Booth Street

Fire Safety Strategy

RIBA Stage 2

Doc ref: BST-HYD-XX-XX-RP-FE-0001

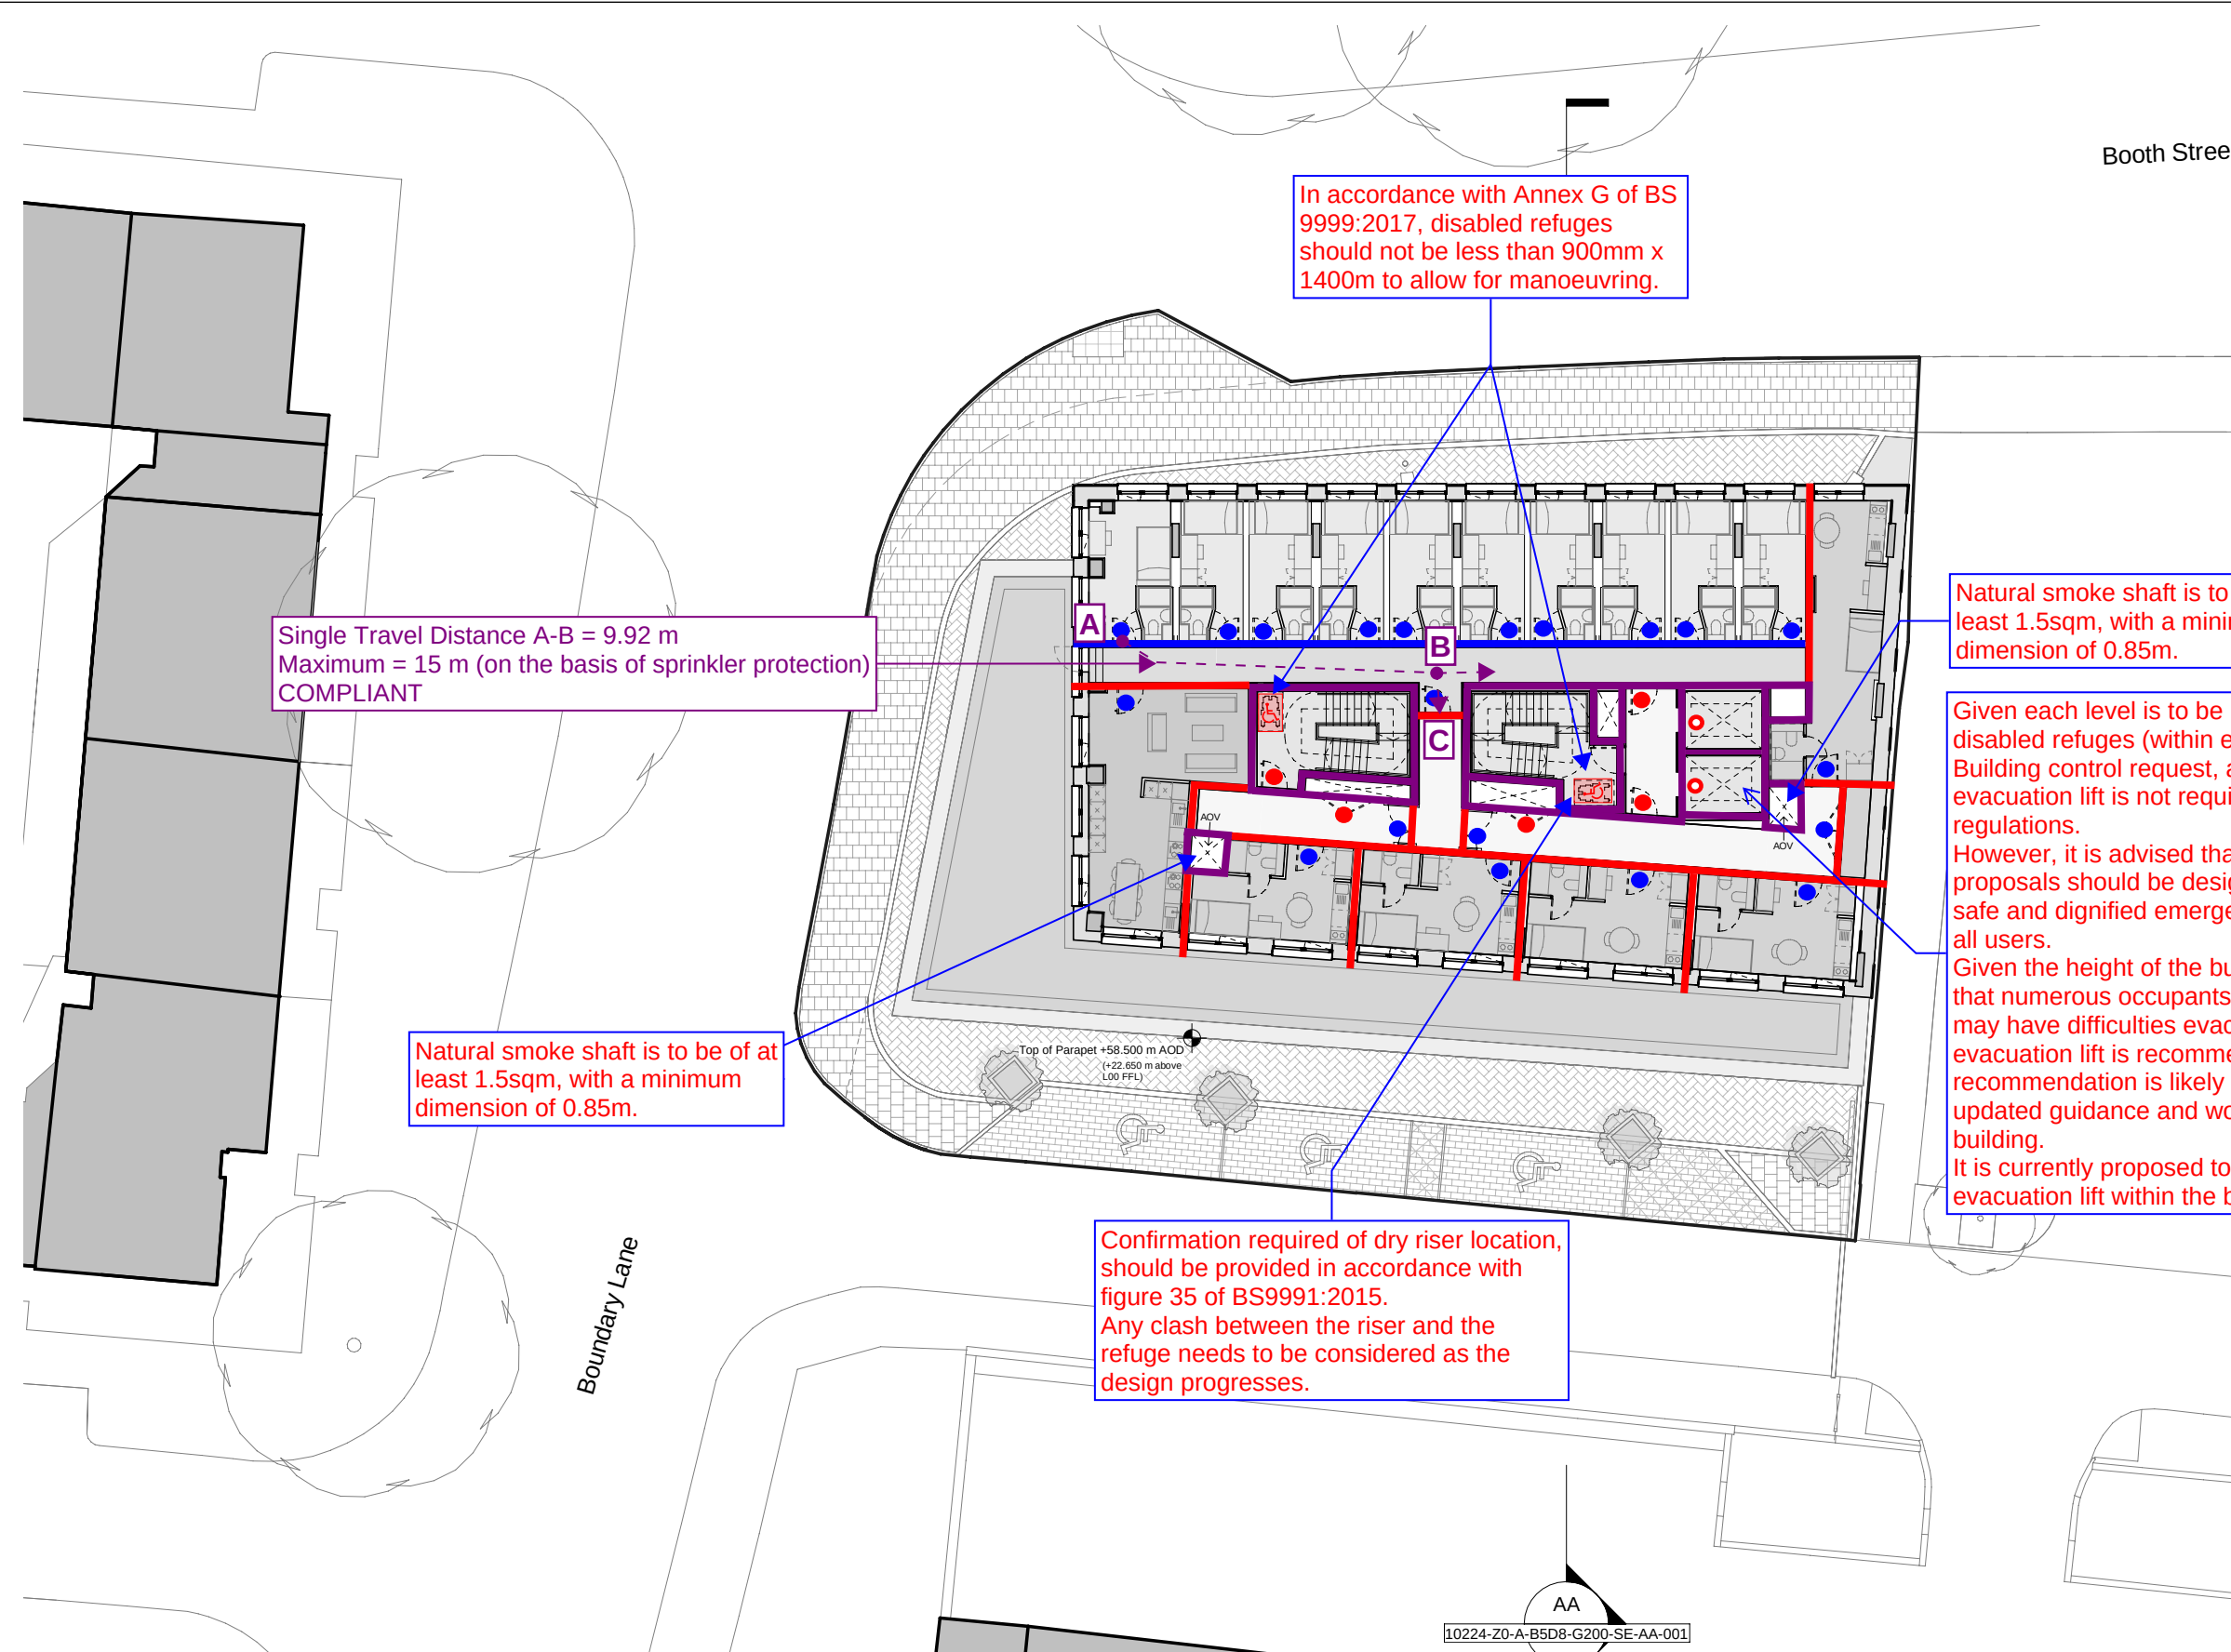
Single Travel Distance A-B = 9.92 m
Maximum = 15 m (on the basis of sprinkler protection)
COMPLIANT

Natural smoke shaft is to be of at least 1.5sqm, with a minimum dimension of 0.85m.

Confirmation required of dry riser location, should be provided in accordance with figure 35 of BS9991:2015. Any clash between the riser and the refuge needs to be considered as the design progresses.

In accordance with Annex G of BS 9999:2017, disabled refuges should not be less than 900mm x 1400m to allow for manoeuvring.

Natural smoke shaft is to be of at least 1.5sqm, with a minimum dimension of 0.85m.

Given each level is to be provided with disabled refuges (within each stair) upon Building control request, a designated evacuation lift is not required under building regulations. However, it is advised that the development proposals should be designed to incorporate safe and dignified emergency evacuation for all users. Given the height of the building and the fact that numerous occupants on the floor plate may have difficulties evacuating the evacuation lift is recommended. This recommendation is likely to be incorporated in updated guidance and would future proof the building. It is currently proposed to provide one evacuation lift within the building.

Drawing Title:
**Fire Strategy Drawing
Typical Plan Type 02 - Level 07**

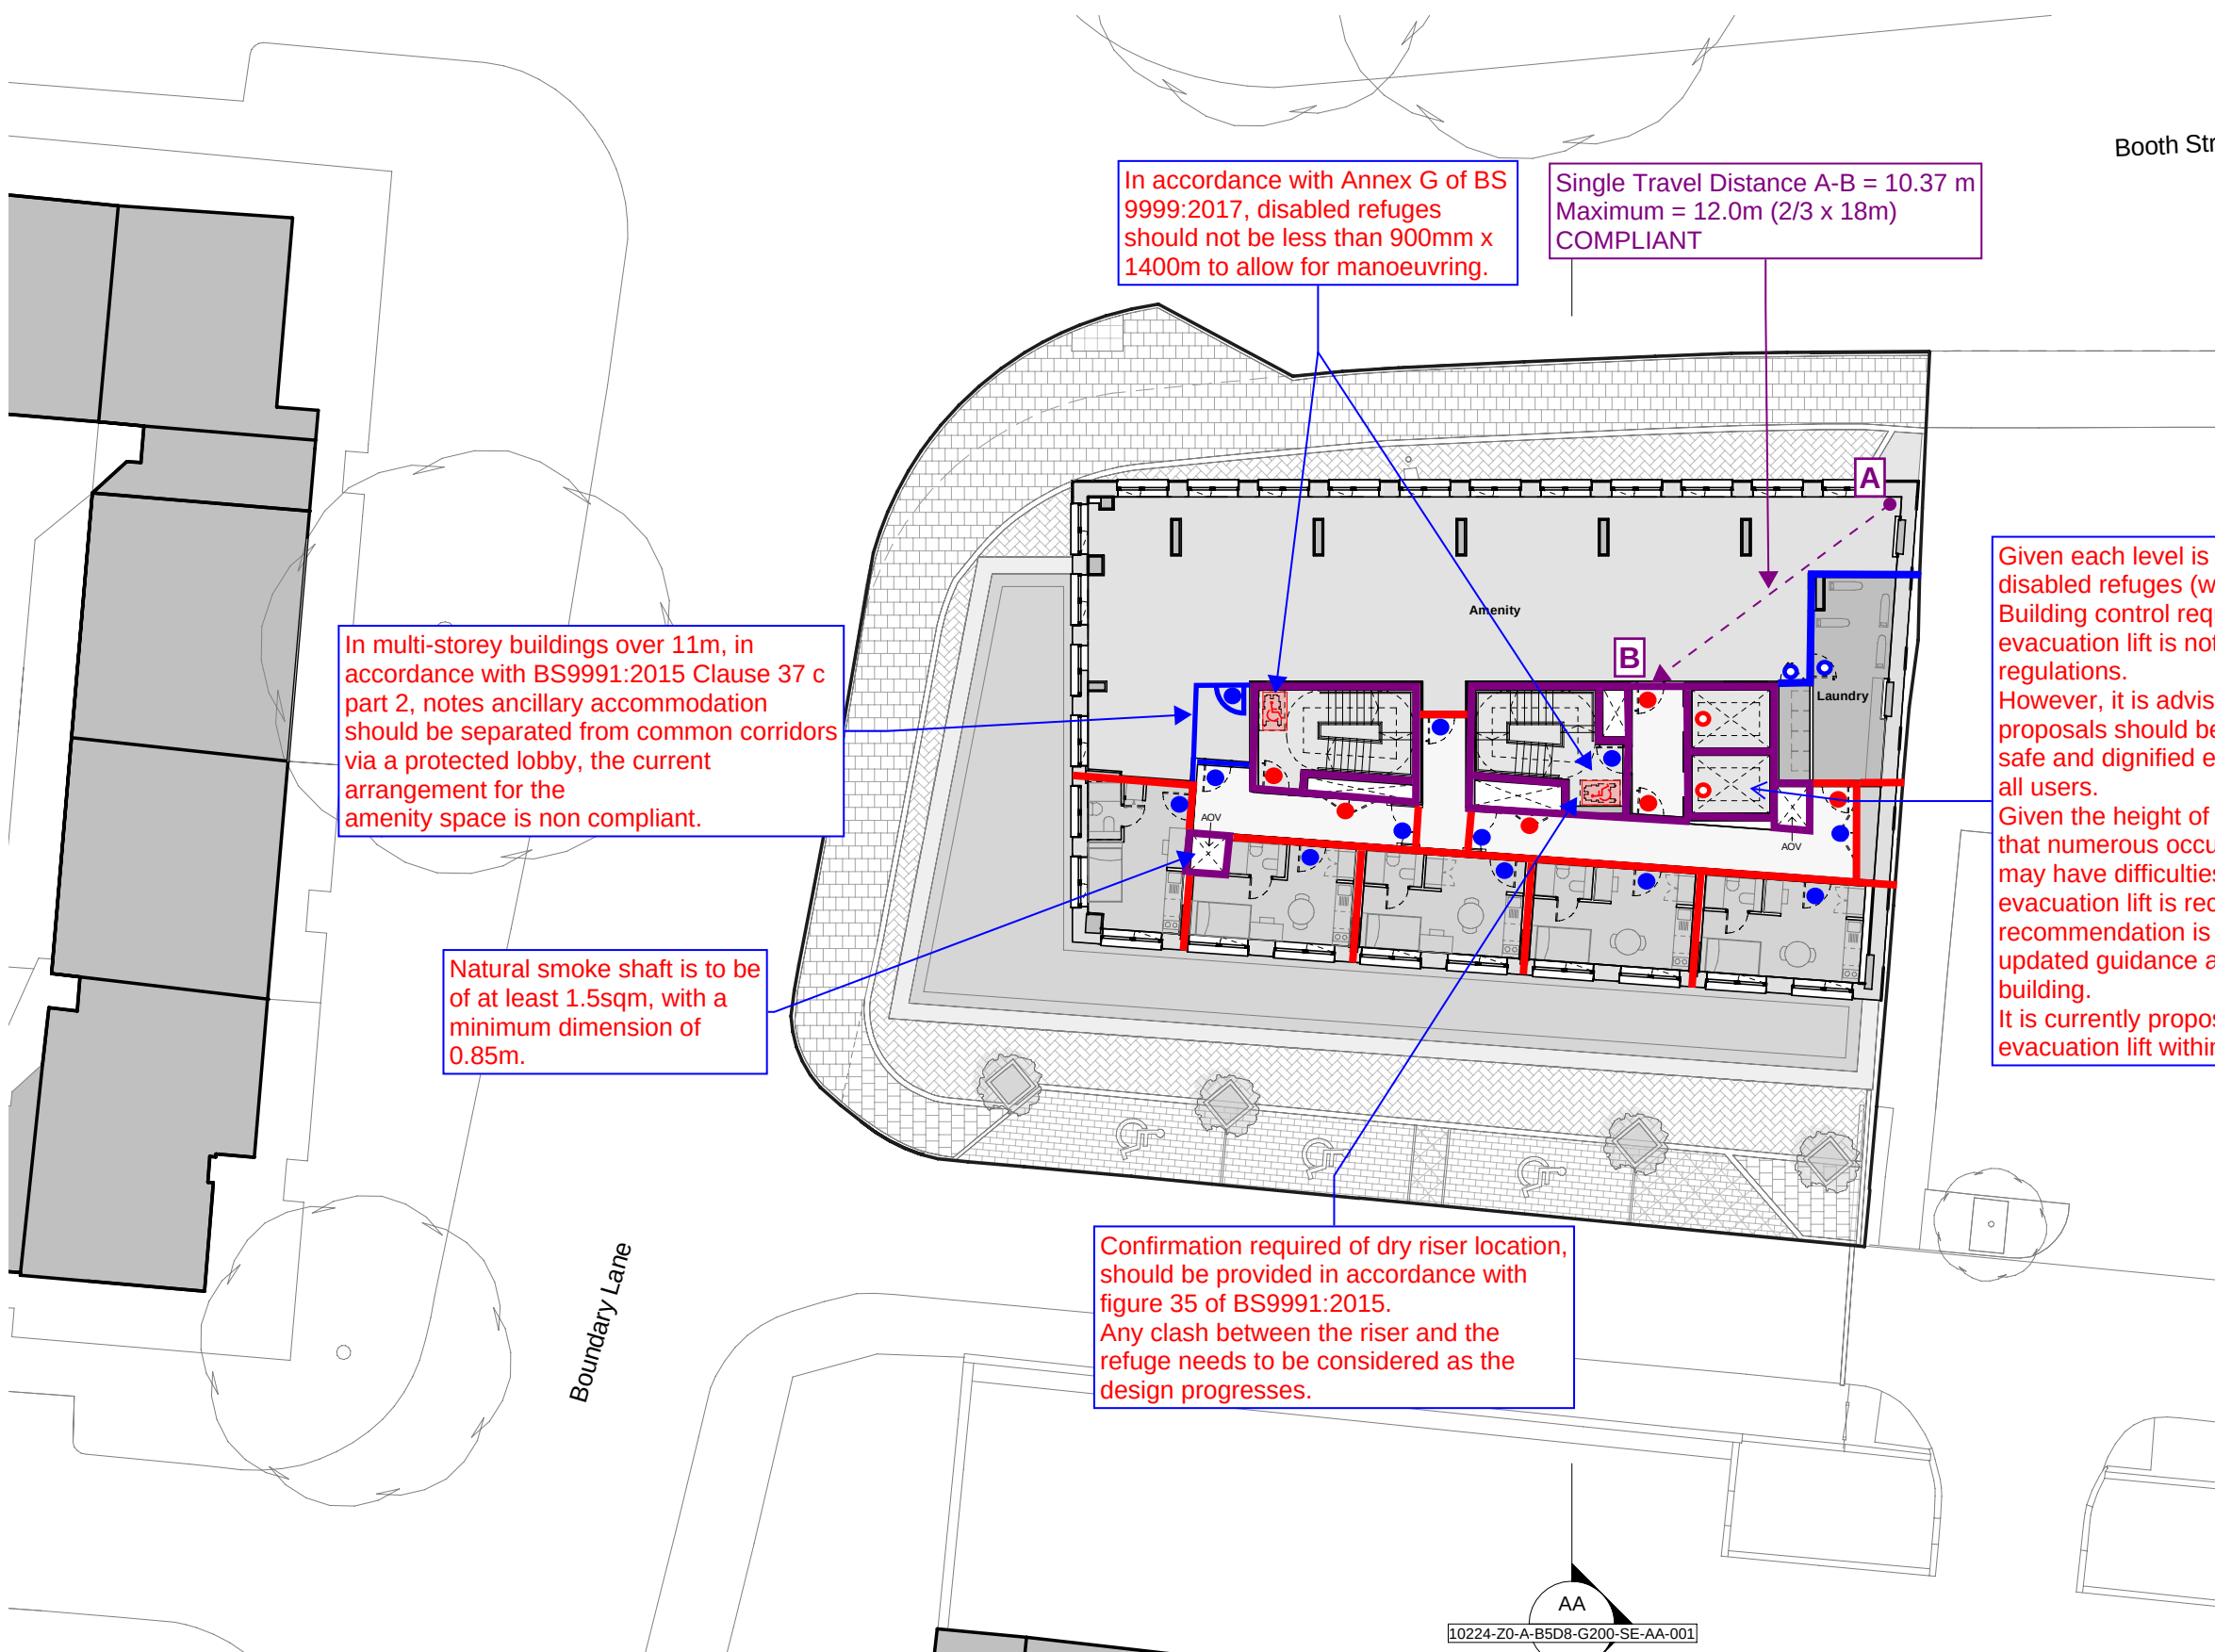
Given each level is to be provided with disabled refuges (within each stair) upon Building control request, a designated evacuation lift is not required under building regulations. However, it is advised that the development proposals should be designed to incorporate safe and dignified emergency evacuation for all users. Given the height of the building and the fact that numerous occupants on the floor plate may have difficulties evacuating the evacuation lift is recommended. This recommendation is likely to be incorporated in updated guidance and would future proof the building. It is currently proposed to provide one evacuation lift within the building.
